DATE: January 25, 2011

SUBJECT: Addendum No. 2
Access Control/CCTV/Intrusion Alarm System for the Human Services/Child Support Services/Health Services Departments Placerville and South Lake Tahoe (Contract No. PW 10-30566, CIP No. 90400)

End of Addendum No. 2

A 4.1

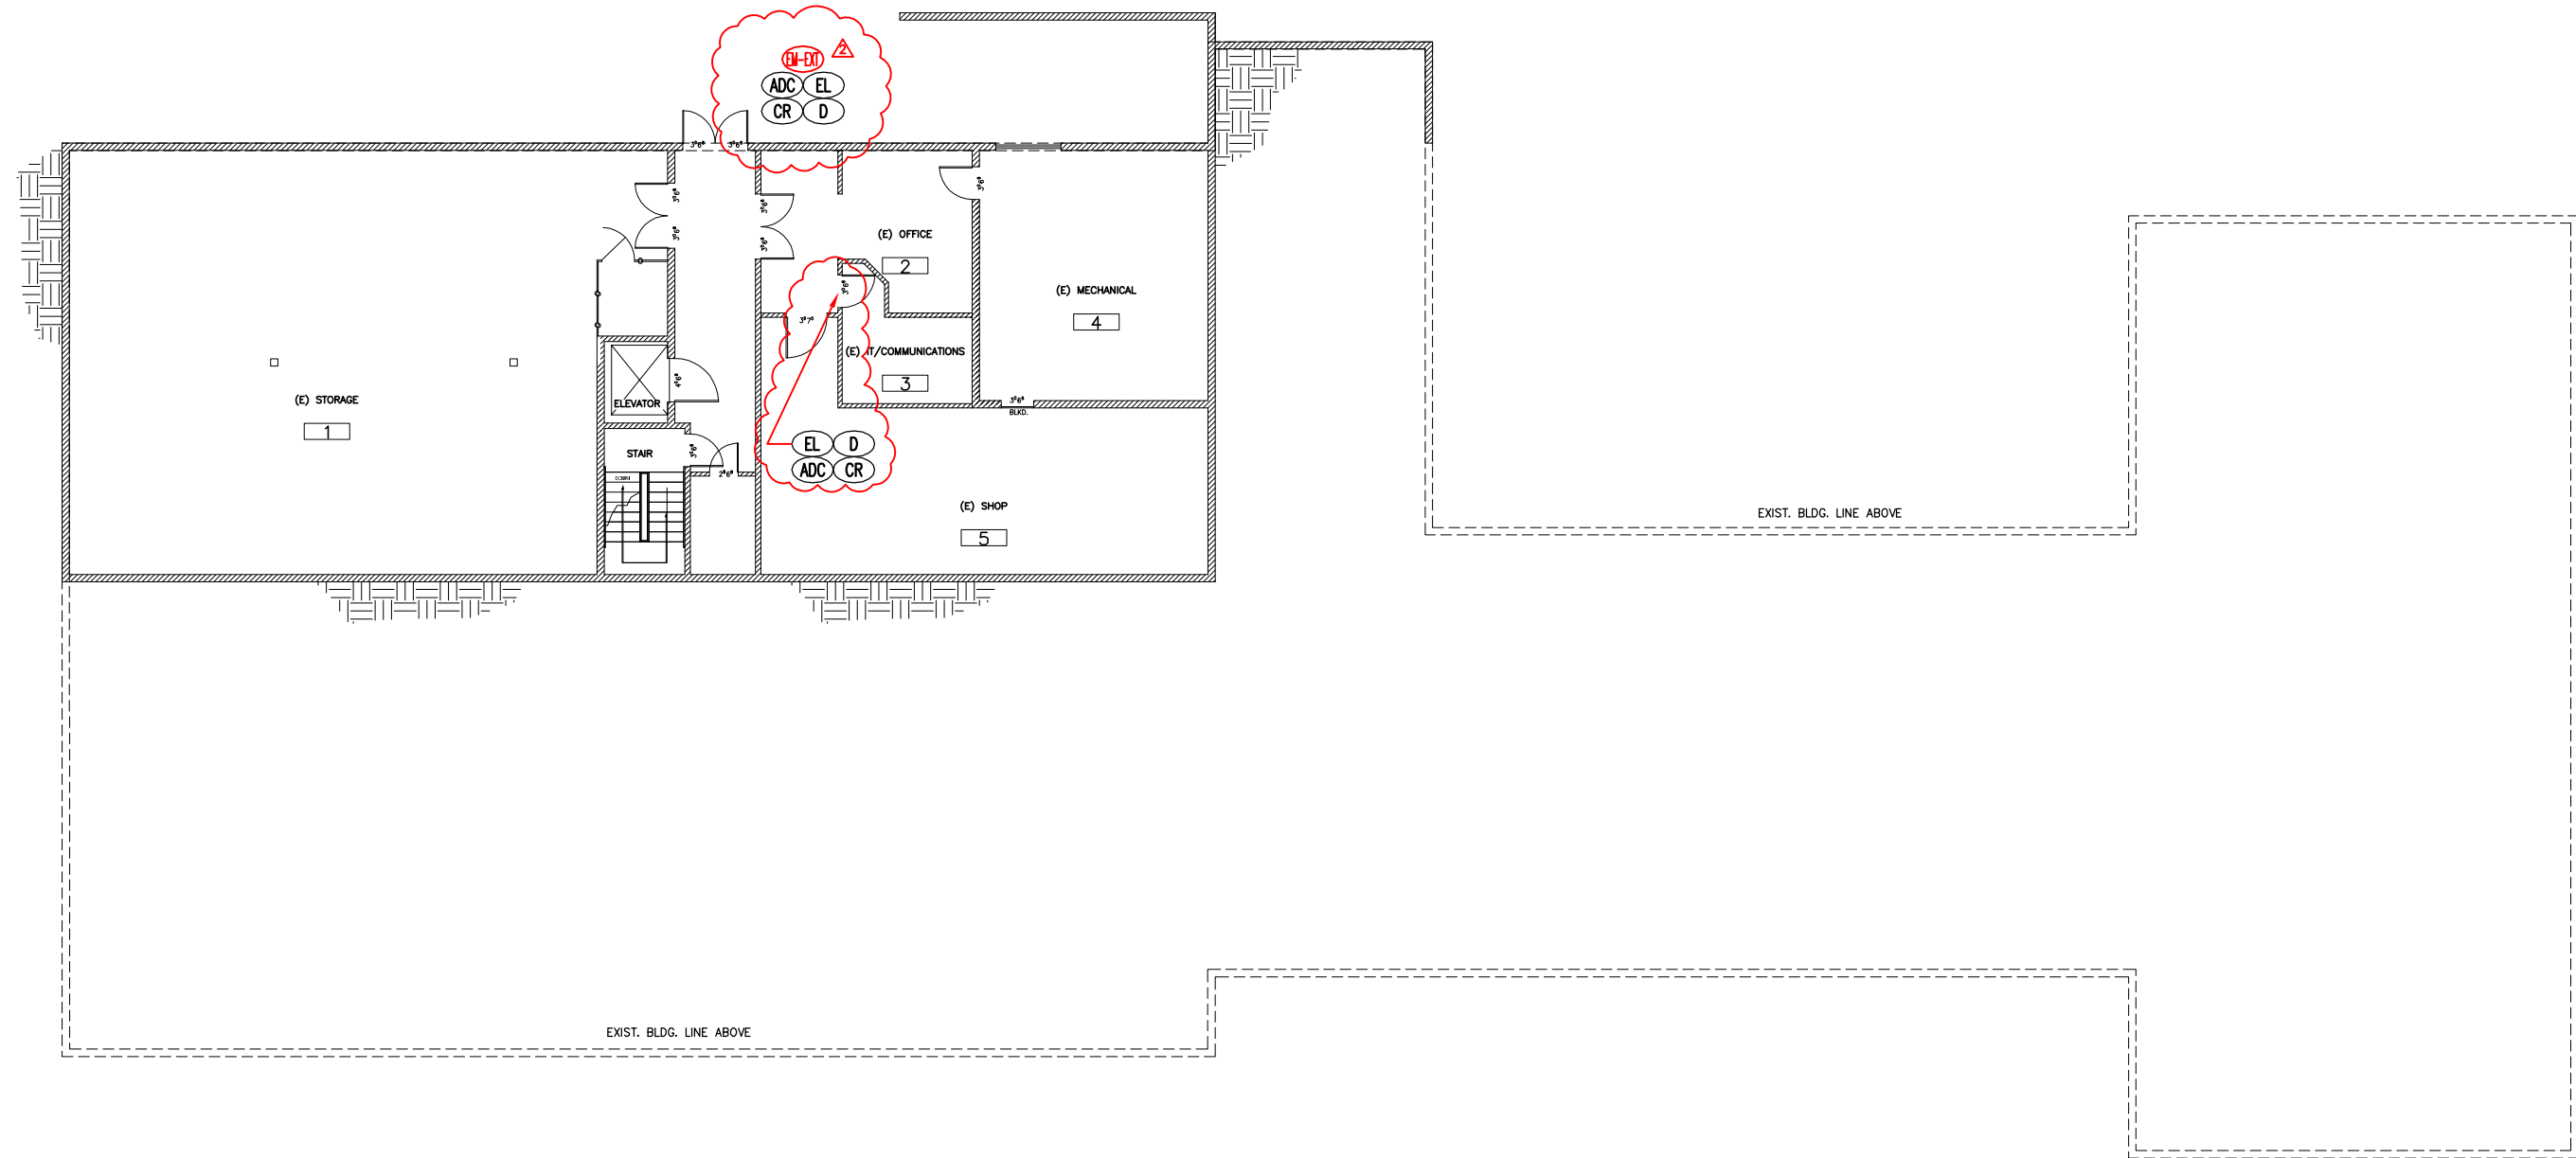
2.08	TS-11	<p>Section 3.2.2 Measurement and Payment”: Add the following after “and miscellaneous work necessary”: <i>“including replacing inoperable hardware and re-hanging the exit door in the Dining Room shown on Plan Sheet A 4.1,”</i></p>

SHEET NO.
A 5.1
PAGE 14 OF 20

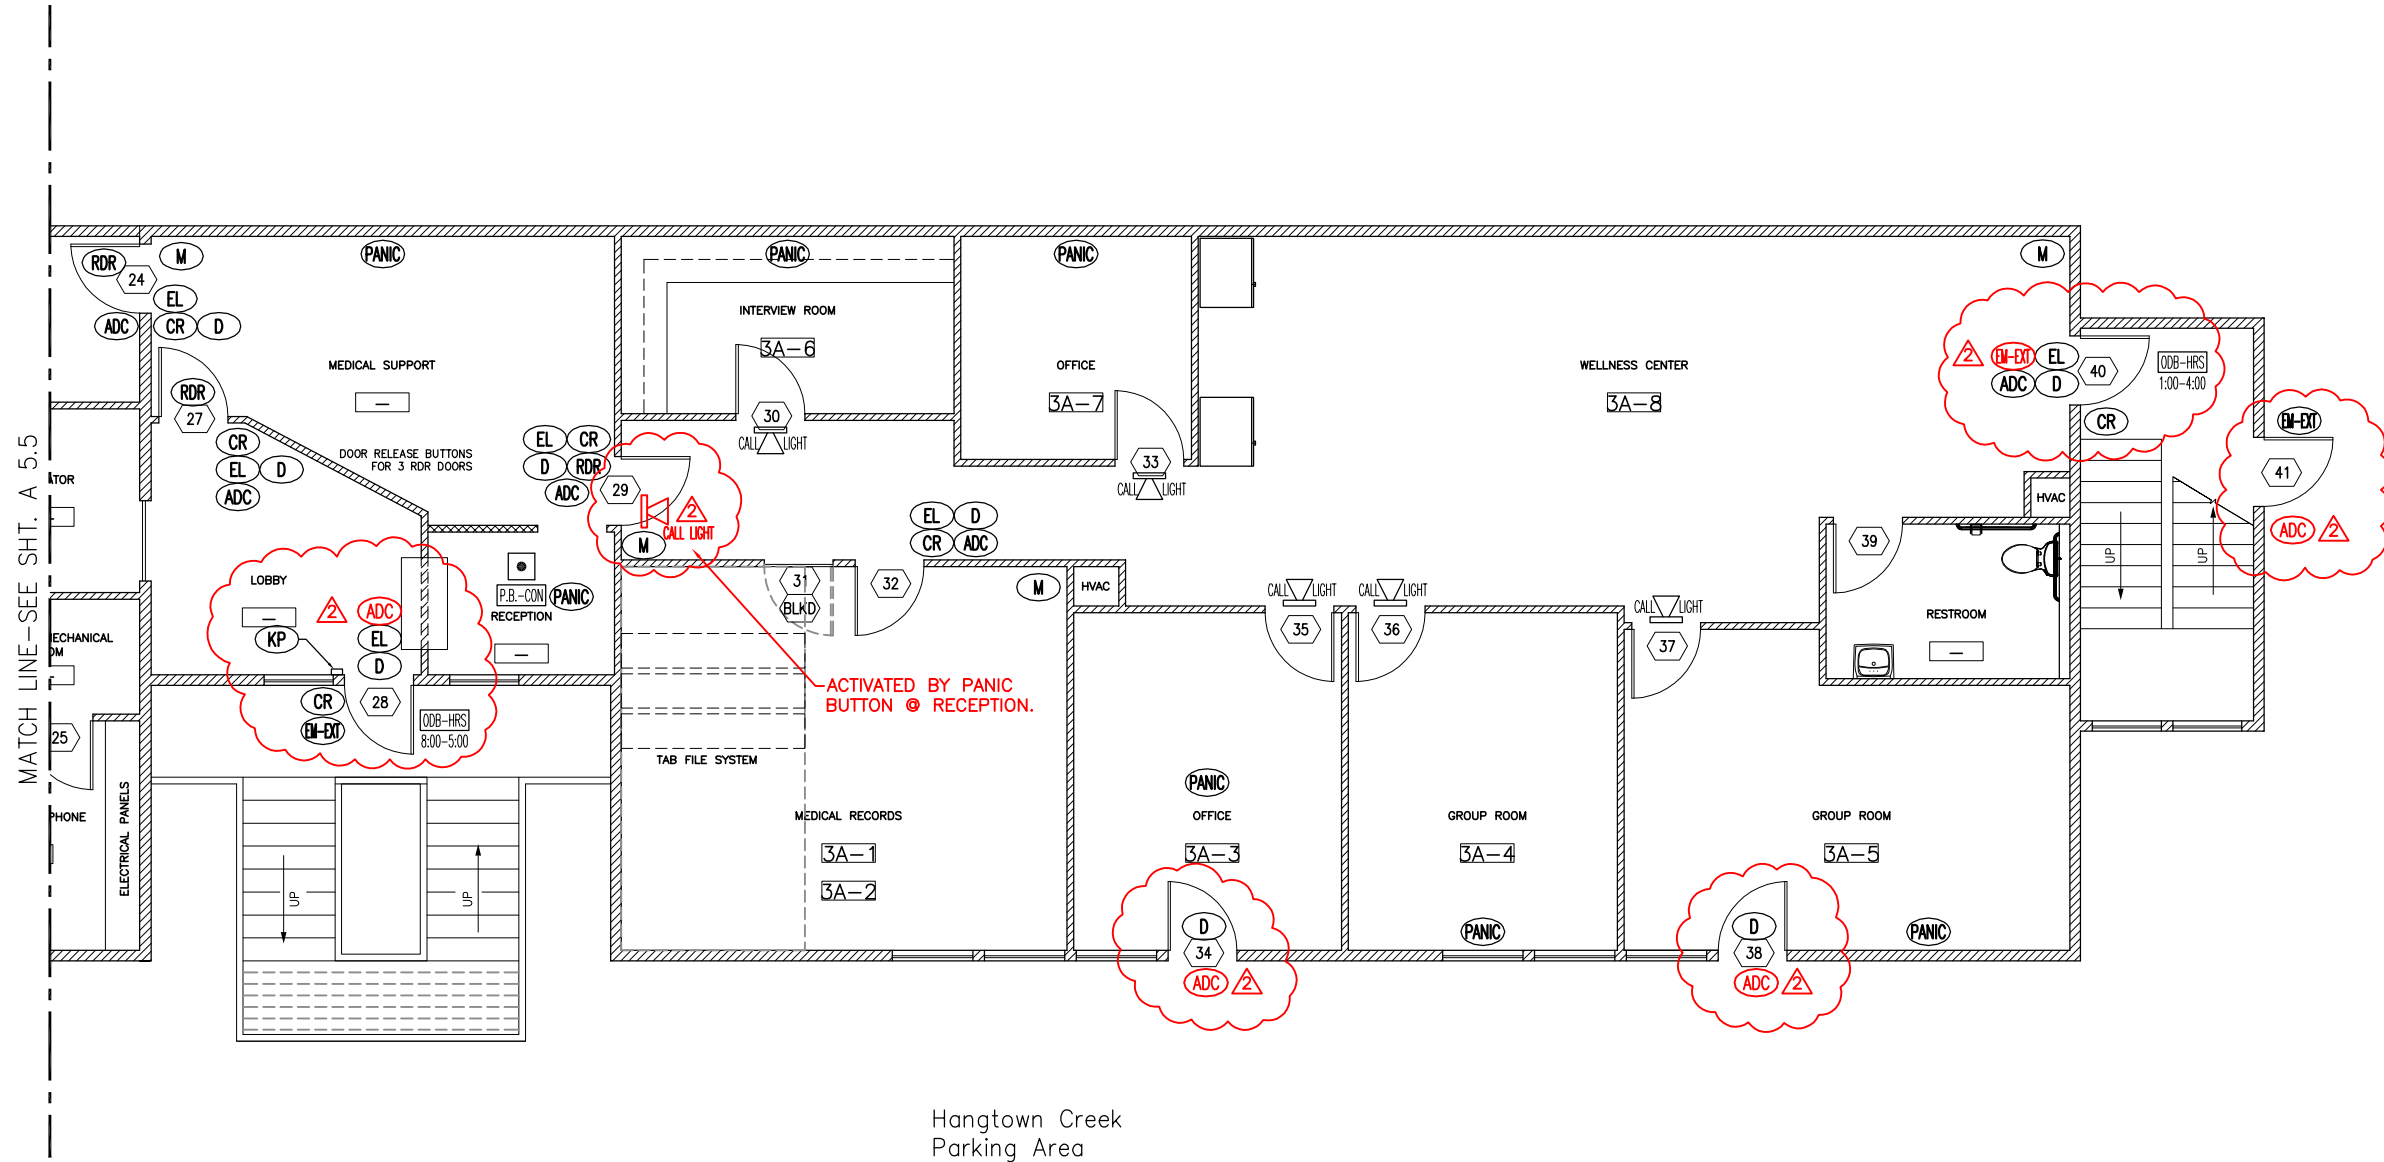
2.06	TS-11, TS-3, and Plan Sheet A 5.1	Question: 1) For 670 Placerville Drive location should we include replacing the door closures to the main lobby? 2) Please clarify whether the wiring for the lobby doors must be run in a wire mold or wire tape. Answer: 1) Add the following to the Measurement and Payment Clause 3.2.2: <i>"The Unit Price bid for Door Package shall include repairing or replacing the existing automatic door closures for the lobby doors shown on Plan Sheet A 5.1."</i> 2) Please add the following to Section 1.3 "Cabling": <i>"The wiring for the Lobby doors at 670 Placerville Drive shown on Plan Sheet A 5.1 shall be run in a wire mold."</i>
